ADDENDUM # 2

Bid 17C8, Butterfly Ridge Elementary School – New School Construction
REVISED DUE DATE: January 26, 2017

BUTTERFLY RIDGE ELEMENTARY – NEW SCHOOL CONSTRUCTION

**BUTTERFLY RIDGE ELEMENTARY SCHOOL
BID PACKAGE
ADDENDUM NO. 2
21347.00**

ADD 2
SKS-6

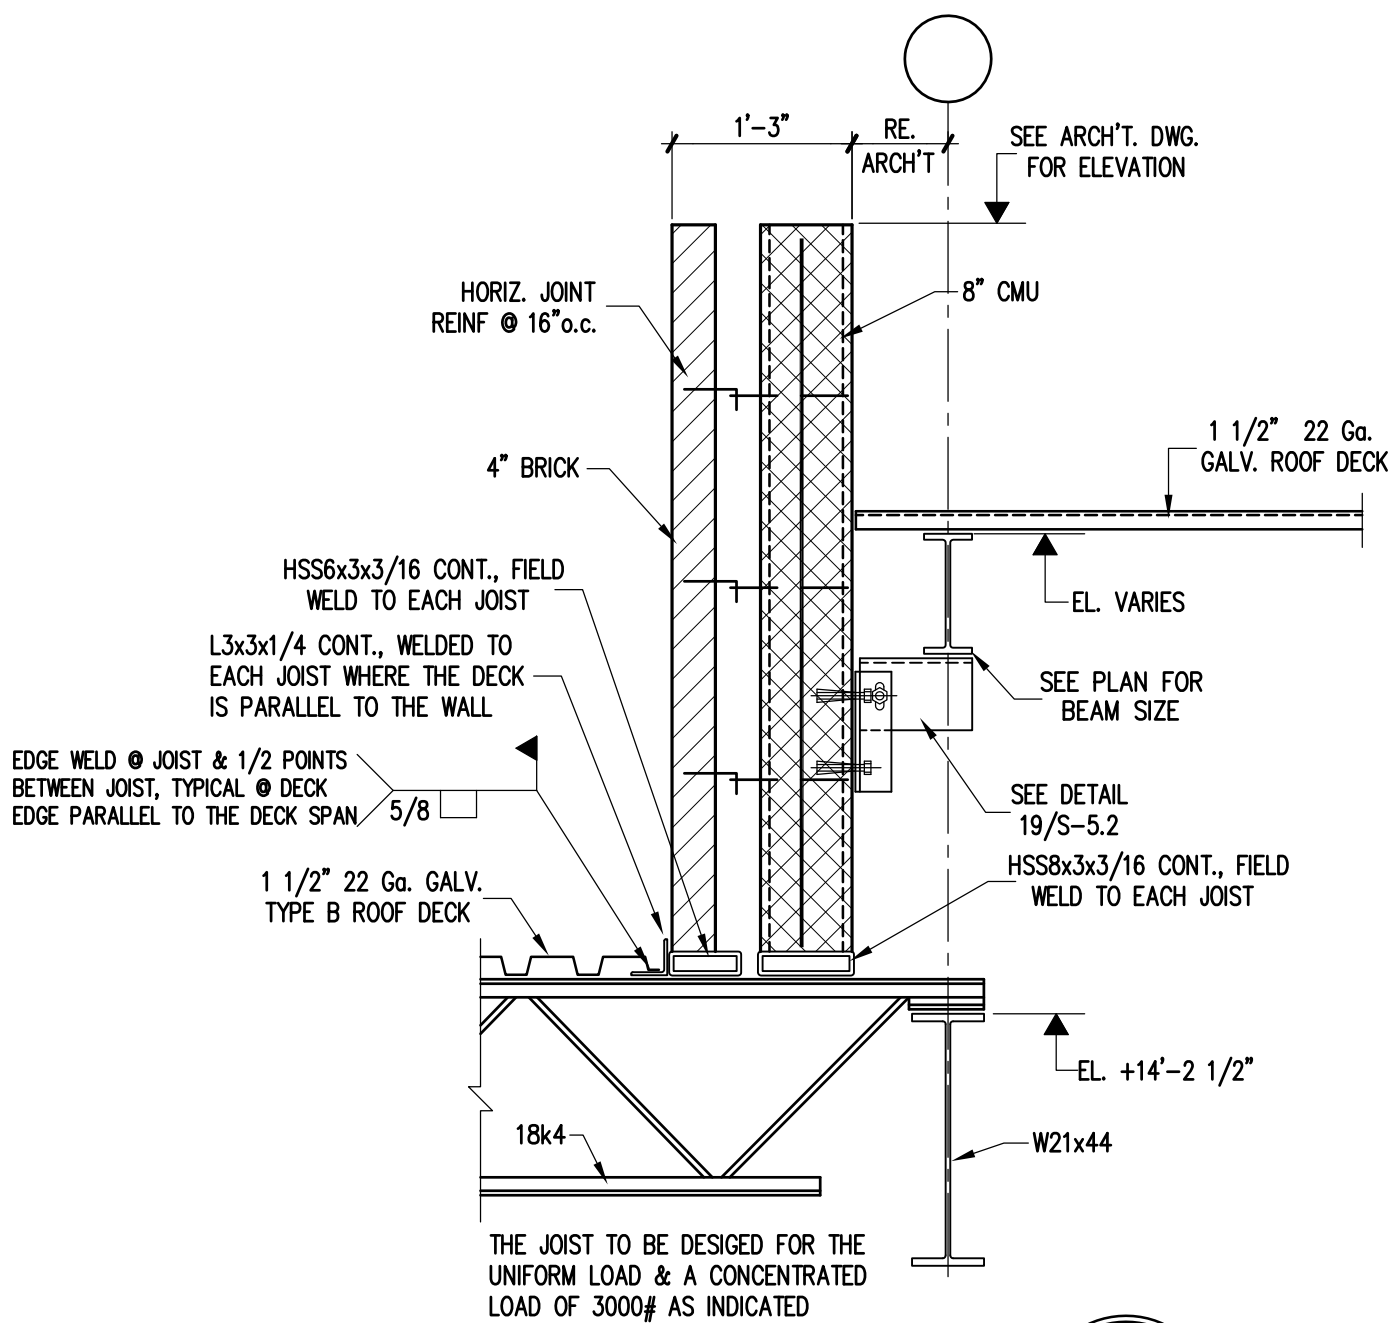
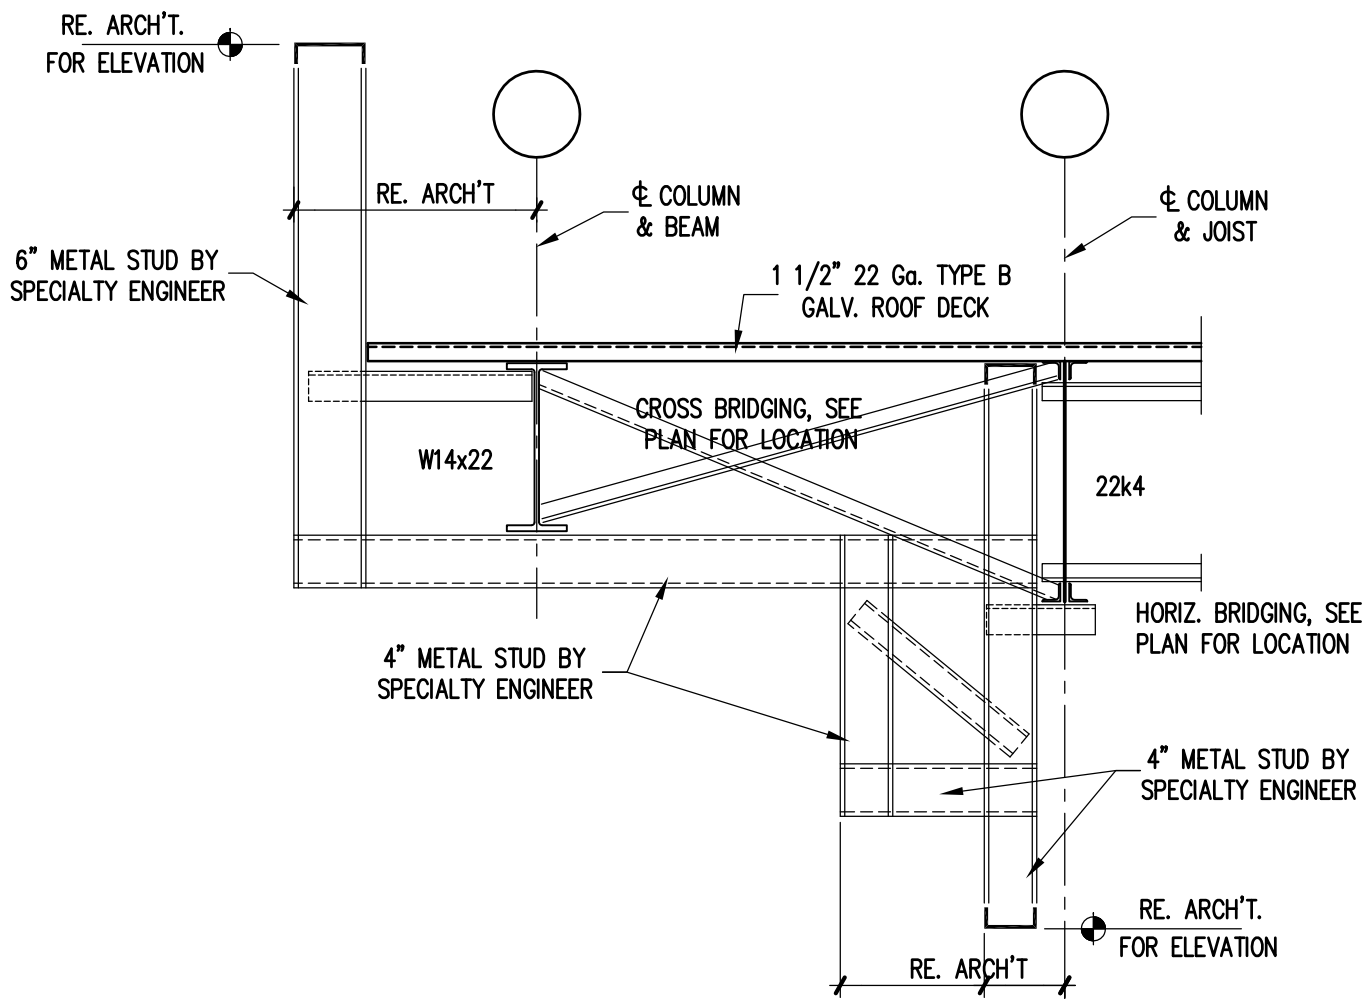
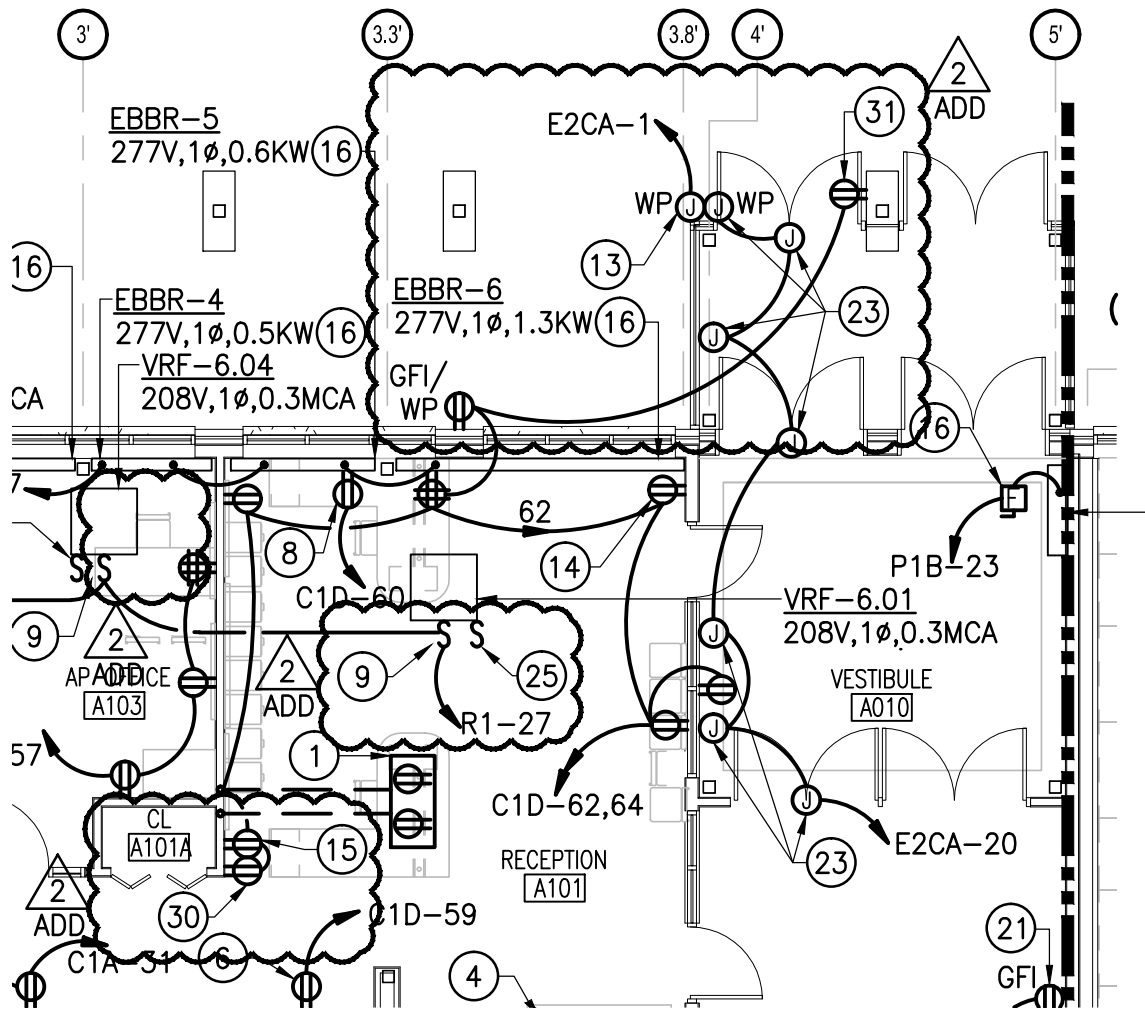
ITEM NO. S7: SHEET S-4.5 SECTIONS
REVISE Section 7 per attached sketch SKS-6.

ITEM NO. S8: SHEET S-4. 6 SECTIONS
REVISE Section 4 per attached sketch SKS-8.

ADD NO. 2
E-1.1.1

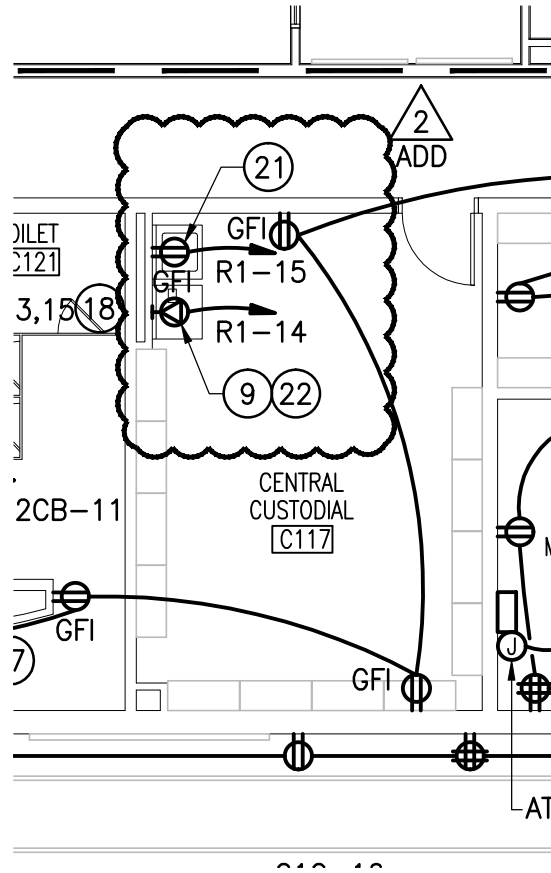
ITEM NO. E3: SHEET E-1.1 PARTIAL FIRST FLOOR PLAN – AREA A – POWER & SPECIAL SYSTEMS
REVISE Note 9 to read as follows: “2P Motor rated switch. Mount at unit and make all connections to VRF Units and to circuit indicated. Provide 2P, 30A FSS (F@20A) adjacent to Panel R1.”
ADD WP/GFI Duplex receptacle and Note 31 for Bird-X equipment. Refer to Sketch E-1.1.1 for additional information.
ADD Duplex receptacle and Note 30 for Alertus System connected to circuit C1D-64 in Reception A101. Refer to Sketch E-1.1.1 for additional information.

REVISION TO DRAWING: E-1.4 - PARTIAL FIRST FLOOR PLAN - AREA C2 - POWER & SPECIAL SYSTEMS

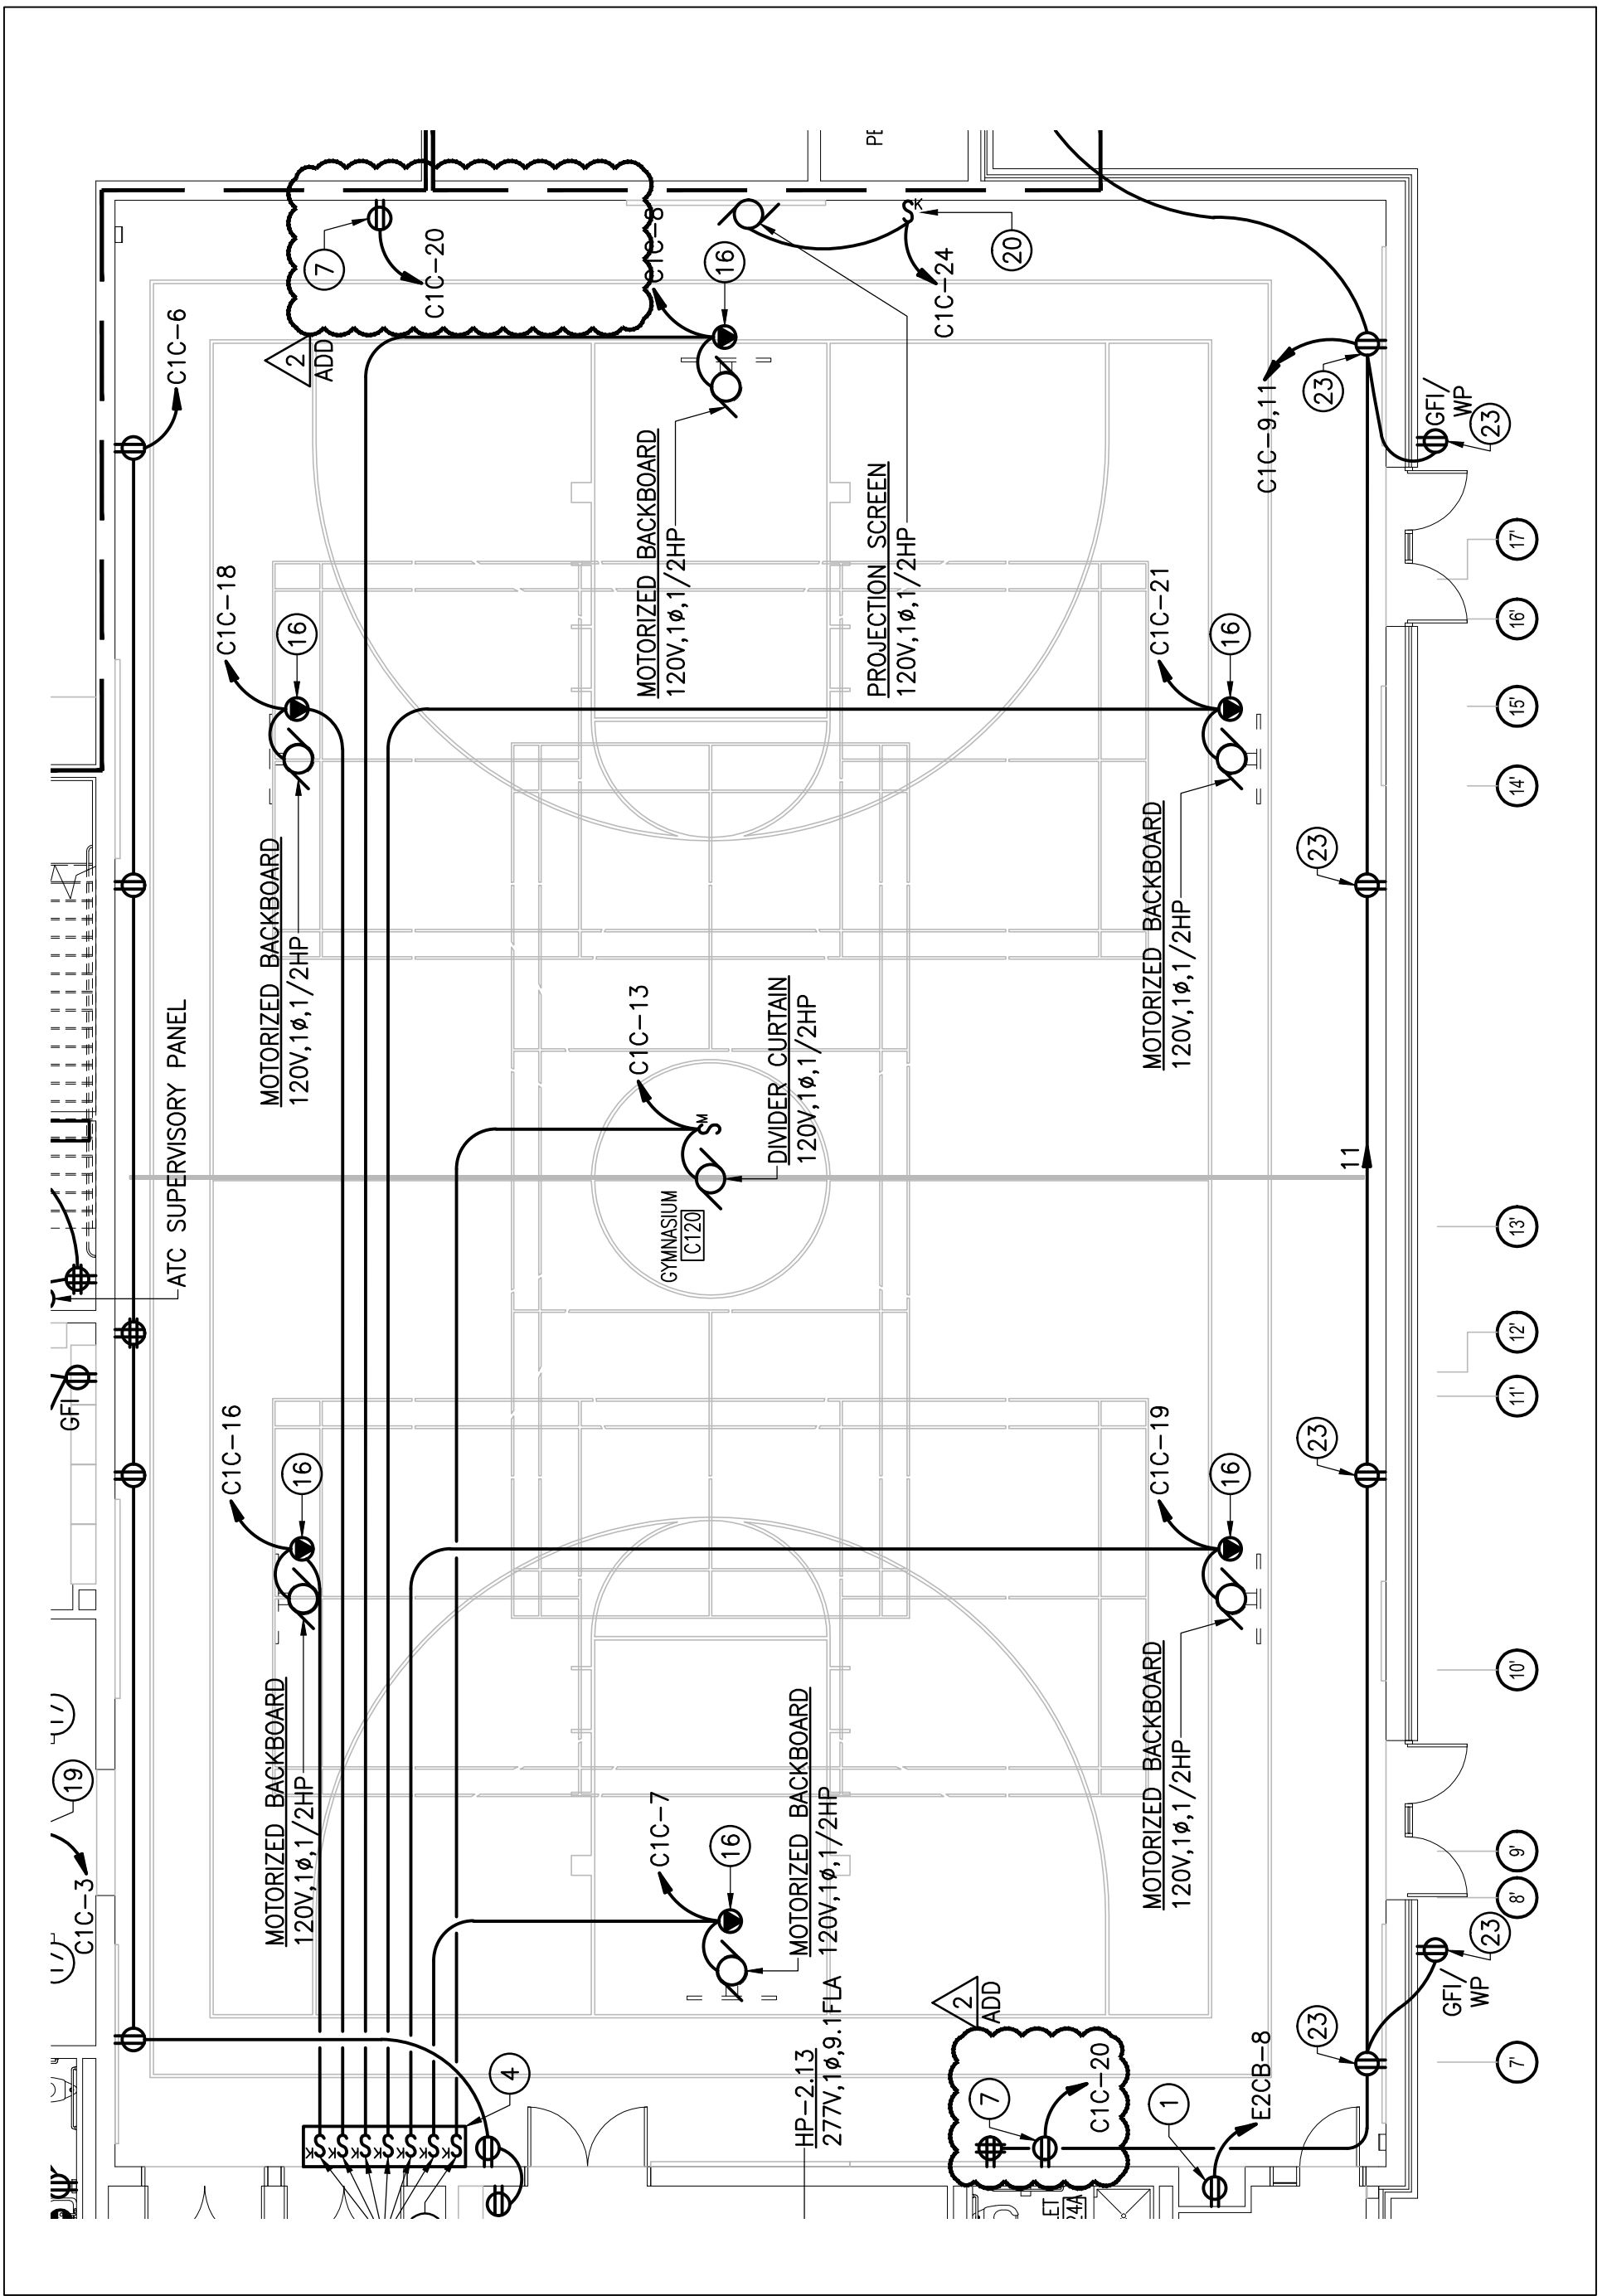
ITEM NO. E4: SHEET E-1.4 PARTIAL FIRST FLOOR PLAN – AREA C2 – POWER & SPECIAL SYSTEMS
REVISE Locations of receptacles for Washer and Dryer in Central Custodial C117. Refer to Sketch E-1.4.1 for additional information.
REVISE Junction box for Scoreboard with Note 7 (Circuit C1C-20) on West Wall in Gymnasium to duplex receptacle and location. Refer to Sketch E-1.4.2 for additional information.
ADD Duplex receptacle on Circuit C1C-20 for scoreboard with Note 7 on East Wall in Gymnasium for Scoreboard. Refer to Sketch E-1.4.2 for additional information.

ADD NO. 2
E-4.2.1

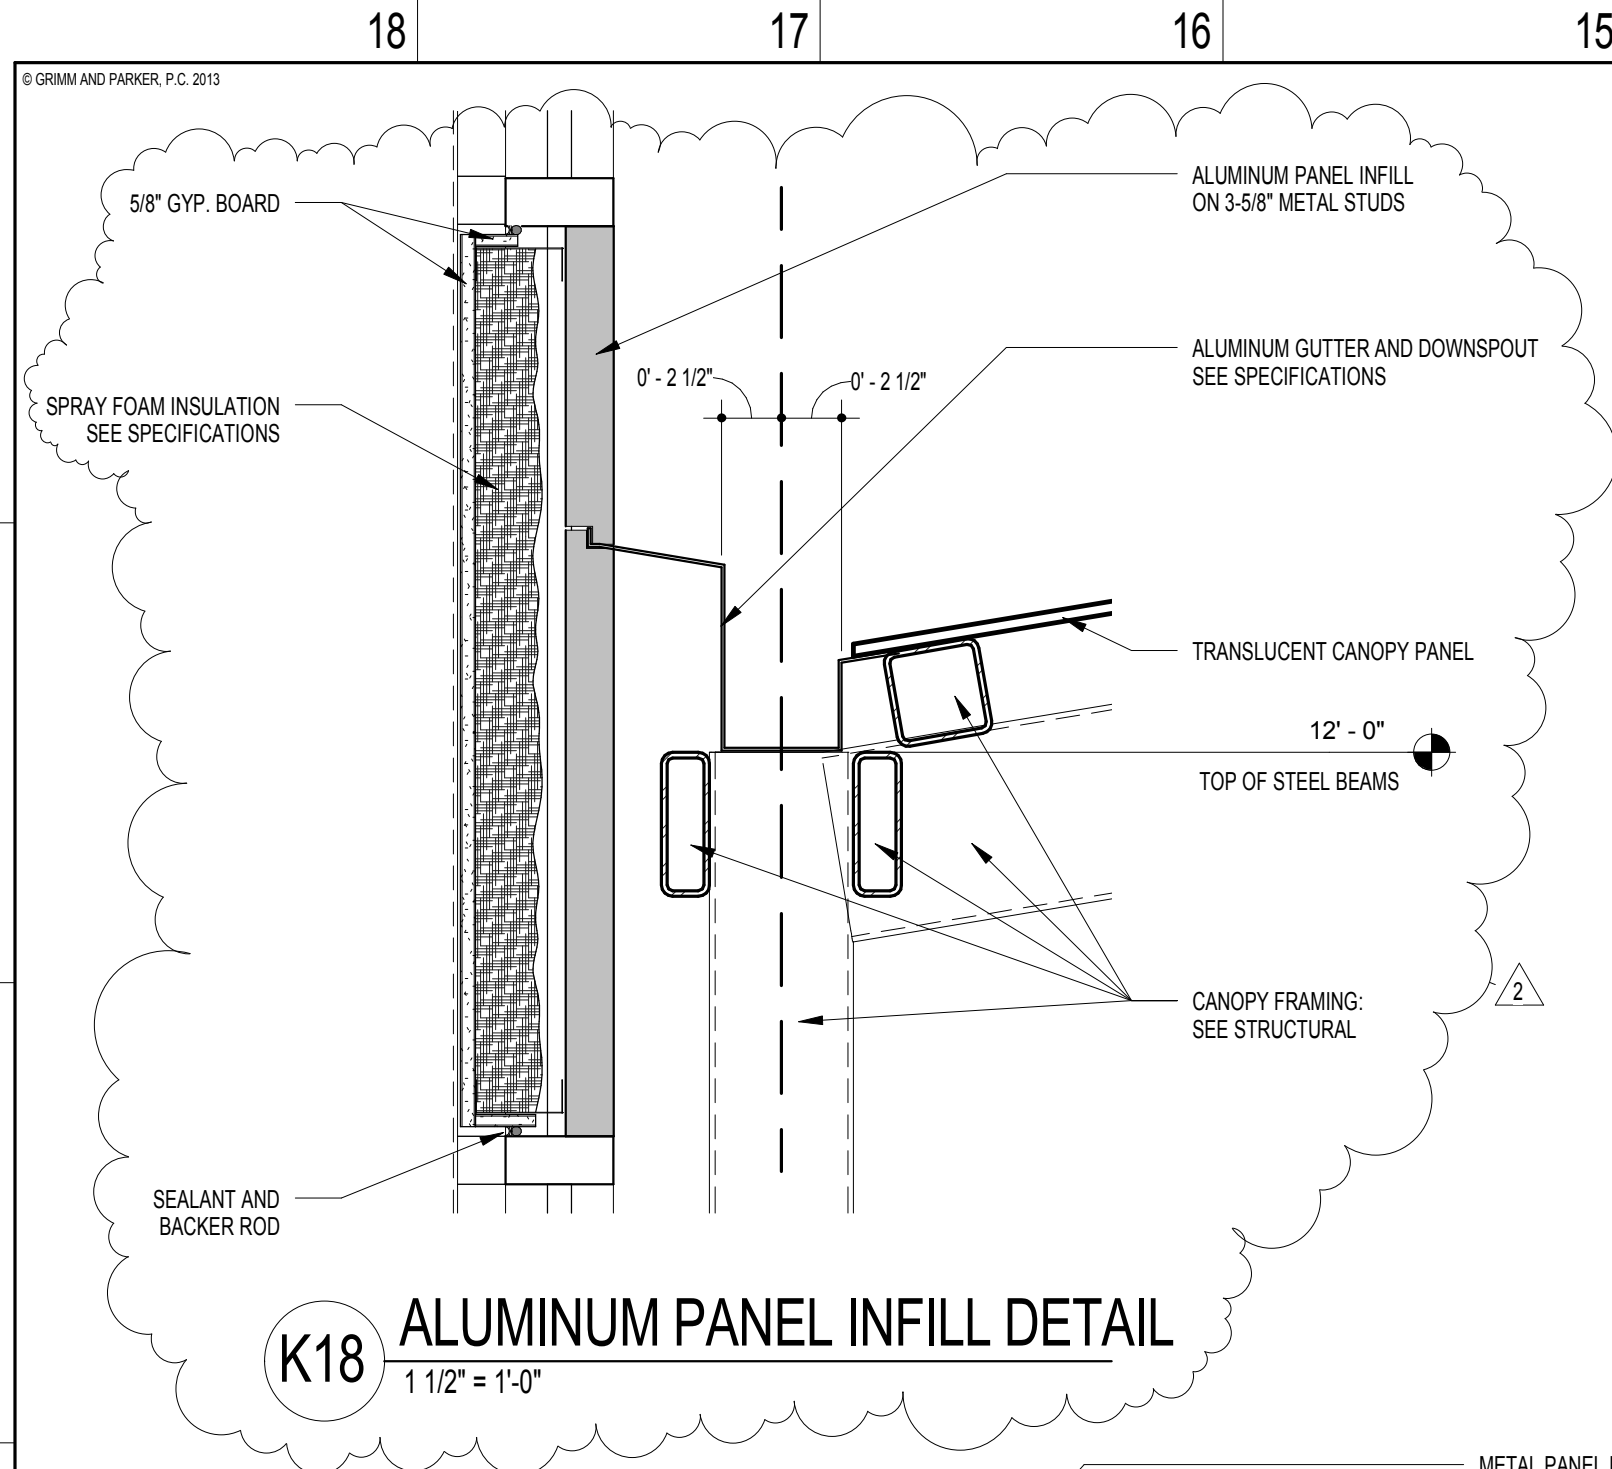
ITEM NO. E8: SHEET E-4.2 PART PLAN - KITCHEN C112 - POWER
REVISE Locations of receptacles for Washer and Dryer in Locker C113. Refer to Sketch E-4.2.1 for additional information.
